UNITED STATES PATENT AND TRADEMARK OFFICE

APPLICATION NO.	FILING DATE	FIRST NAMED INVENTOR	ATTORNEY DOCKET NO.	CONFIRMATION NO.
10/507,379	03/18/2005	Jari Ylitalo	108306-00025	2097

Office Action Summary	Application No.	Applicant(s)	
	10/507,379	YLITALO, JARI	
	Examiner	Art Unit	
	Paul Ip	2837

DETAILED ACTION

Fig. 3.

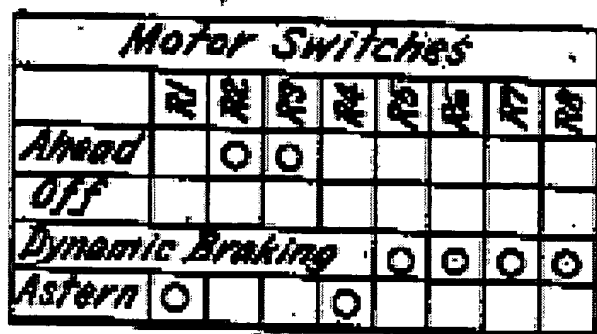
The patent to Frisch shows in figure 3 the motor switches off when the dynamic braking switches are connected to the resistors.

Kilgore does not clearly specify disconnect the electrical power network. However, the patents to Schmucker et al and Frisch disclose disconnect the electrical power network during dynamic braking and before reverse the motor direction. Prima facie case is made that Kilgore disclosed the switch 20 can be closed with frequency converter 22 set to output a frequency equivalent to that of the generator and the generator 12 can then be electrically disconnected from the motor 16 by opening switch 18. When performing the dynamic braking of a motor, one of ordinary skill in the art would disconnect the motor from the electrical power network in order to prevent the electrical power network damage during the dynamic braking. One of ordinary skill in the art would disconnect Kilgore's electrical power network from the motor as taught or suggested by Schmucker et al or Frisch to prevent the damage of the electrical power network during the dynamic braking.
